Re: 2139 NW Killarney Ln. - Framing Evaluation Report
Lee's Summit, Missouri
Bldg Permit No.: PRRES20243851

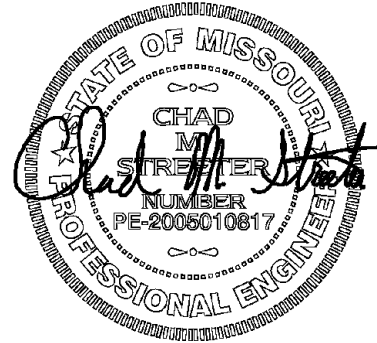
This letter is in regard to the connection of the lower and upper deck posts at the front of the deck located at the above mentioned residence. We had noted that the posts supporting the deck and roof structure above the deck had been discontinued at the deck level and were screwed to the portion of the post that projected along inside of the header. In order to provide a more secure and positive connection between the posts and the deck, we recommend that a minimum of four 5" long HeadLOK screws be installed from the top of the lower post into the bottom of the deck header and from the bottom of the upper post into the top of the deck header. We recommend that two screws be installed on opposite sides of the post.
